Intersection ID: 48773	Main Street: OLD_FORESTER_LN	Cross Street: SONOMA_VALLEY_DR	Location:	NE
ADA ID: A873DE2537C8	Ramp Type: PerpDiag	Initial Pass/Fail: Fail	Overall Compliance: No	Severity Score: 8.75

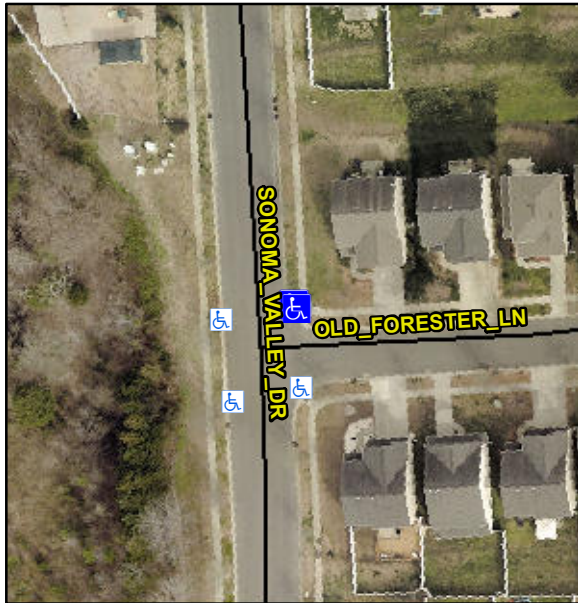
Not Found, R304.5.1

Compliance	Description	Data	Compliance	Description	Data
N/A	Ramp Length (in)	78.5	Yes	Ramp Slope (%)	5.5
No	Ramp Width (in)	47.5	Yes	Ramp XSlope (%)	1.2
N/A	Flare Type LT	N/A	N/A	Flare Type RT	N/A
N/A	Flare Slope LT (%)	N/A	N/A	Flare Slope RT (%)	N/A
N/A	Flare Traversable LT?	N/A	N/A	Flare Traversable RT?	N/A
N/A	Landing Length (in)	N/A	N/A	DWS Provided?	N/A
N/A	Landing Width (in)	N/A	N/A	DWS Contrast?	N/A
N/A	Landing Slope (%)	N/A	N/A	DWS Length (in)	N/A
N/A	Landing X Slope (%)	N/A	N/A	DWS Full Width?	N/A
N/A	Landing Curb? (Y/N)	N/A	N/A	DWS Offset (in)	N/A
N/A	Shared Landing?	N/A			
N/A	Gutter Ponding?	N/A	N/A	Gutter Slope (%)	N/A
N/A	Gutter Lip Ht (in)	N/A	N/A	Gutter X Slope (%)	N/A
N/A	Painted X Walk1?	No	N/A	Painted X Walk2?	No
	X Walk 1 Direction	To W		X Walk 2 Direction	To S
N/A	X Walk 1 Width (in)	N/A	N/A	X Walk 2 Width (in)	N/A
	X Walk 1 Slope (%)	1.9		X Walk 2 Slope (%)	1.8
	X Walk 1 X Slope (%)	1.7		X Walk 2 X Slope (%)	0.0

Remove & Replace Curb Ramp With Two New Directional Ramps or Equivalent.
